# Access Compliance Report

## Public Rights-of-Way

Intersection ID: 14536	Main Street: CARONIA_ST	Cross Street: RIDGE_AV	Location: NW
ADA ID: 660D8657491B	Ramp Type: PerpDiag	Initial Pass/Fail: Fail	Overall Compliance: No
Severity Score: 55			
Codes/Mitigation Info/Possible Solution		Field Measurements/Component Compliance

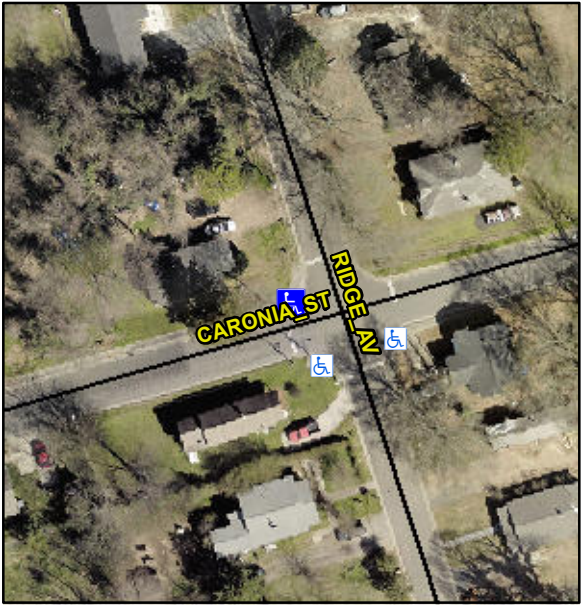
Possible Solutions:	Compliance	Description	Data	Compliance	Description	Data
	Remove & Replace Curb Ramp With Two New Directional Ramps or Equivalent.	N/A	Ramp Length (in)	66.0	No	Ramp Slope (%)	11.3
		No	Ramp Width (in)	34.0	No	Ramp XSlope (%)	11.1
		N/A	Flare Type LT	N/A	N/A	Flare Type RT	N/A
		N/A	Flare Slope LT (%)	N/A	N/A	Flare Slope RT (%)	N/A
		N/A	Flare Traversable LT?	N/A	N/A	Flare Traversable RT?	N/A
		N/A	Landing Length (in)	N/A	N/A	DWS Provided?	N/A
		N/A	Landing Width (in)	N/A	N/A	DWS Contrast?	N/A
		N/A	Landing Slope (%)	N/A	N/A	DWS Length (in)	N/A
		N/A	Landing X Slope (%)	N/A	N/A	DWS Full Width?	N/A
		N/A	Landing Curb? (Y/N)	N/A	N/A	DWS Offset (in)	N/A
		N/A	Shared Landing?	N/A			
		N/A	Gutter Ponding?	N/A	N/A	Gutter Slope (%)	N/A
		N/A	Gutter Lip Ht (in)	N/A	N/A	Gutter X Slope (%)	N/A
		N/A	Painted X Walk1?	No	N/A	Painted X Walk2?	No
			X Walk 1 Direction	To S		X Walk 2 Direction	To E
		N/A	X Walk 1 Width (in)	N/A	N/A	X Walk 2 Width (in)	N/A

X Walk 1 Slope (%)	3.7		X Walk 2 Slope (%)	10.0
			X Walk 1 X Slope (%)	5.3		X Walk 2 X Slope (%)	6.0
		N/A	Ramp inside XWalk1?	N/A	N/A	Ramp inside XWalk2?	N/A
<p>Surveyor Notes:</p> <p>N/A</p> <p>PROW/ADA:</p> <p>Not Found, R304.5.1, R304.2.2, R304.5.3</p>			Road Slope (%)	8.4	N/A	Clear Space?	N/A
			Road X Slope (%)	2.8	N/A	Clear Space to XWalk (in)	N/A
<p>Total Cost:</p> <p>\$ 3200.00</p>		N/A	Any Obstructions?	N/A	N/A	Storm Grate/Utility Hazard?	N/A
			Obstruction Type			Storm Grate/Utility Type	
				N/A			N/A
					Yes	Surface Condition? (G/P)	Good
